Access Compliance Report
Public Rights-of-Way
(Pedestrian Signals)

ADA ID: 8F7C4FEA63D0 **Signal Type:** Two Push Buttons-Non APS **Overall Compliance:** No **Severity Score:** BTN 1: N/A BTN 2: N/A No BTN: N/A

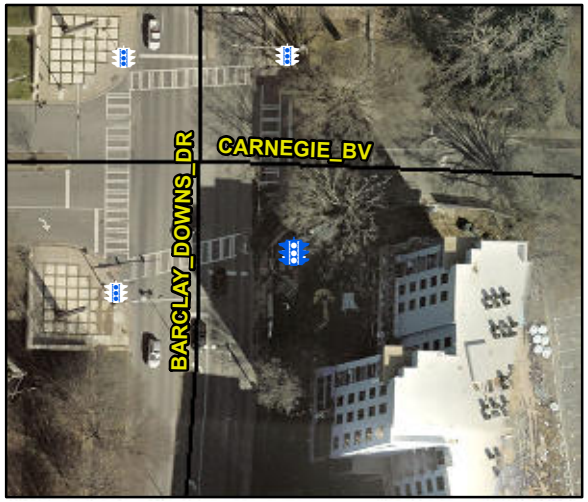
Surveyor Notes: UNDER CONSTRUCTION

PROW/ADA: TMUTCD 4e.08, R404.1, R404.7.1, R404.7.2

Possible Solutions: Replace Signal Push Button With APS Button on New Post. Remove & Relocate Sign.
